# Service Bulletin

**Subject:** Information on Diesel Exhaust Fuel (DEF) Leaking Past Filler Cap

Brand:	Model:	Model Year:		VIN:		Engine:	Transmission:
		from	to	from	to		
Chevrolet	Colorado	2016	2017			LWN	
GMC	Canyon

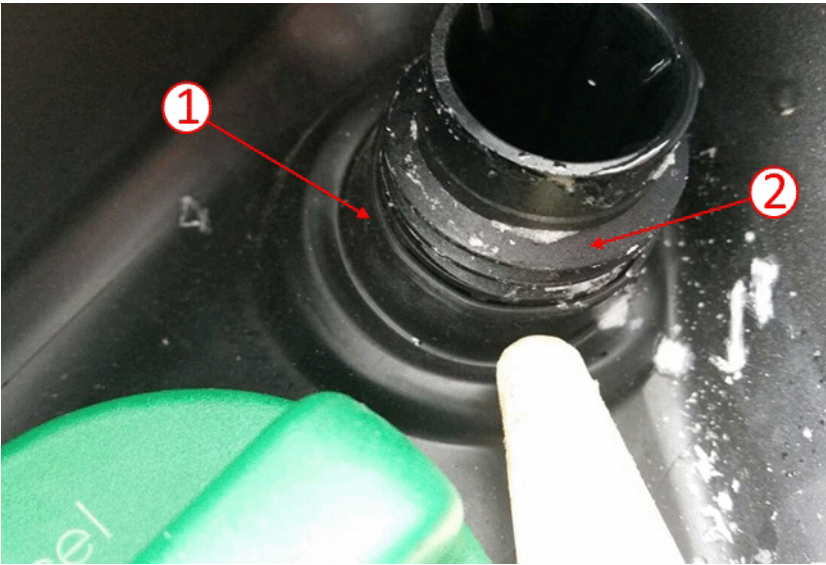
<b>Involved Region or Country</b>	North America
<b>Condition</b>	<p>Some customers may comment on one or more of the following conditions:</p> <ul style="list-style-type: none"> <li>• DEF leaking at the filler pipe.</li> <li>• DEF filler cap doesn't install completely/properly.</li> </ul>
<b>Cause</b>	 <p>This condition may be caused by the grommet (1) in the fuel housing expanded around the DEF filler pipe cap threads (2).</p>
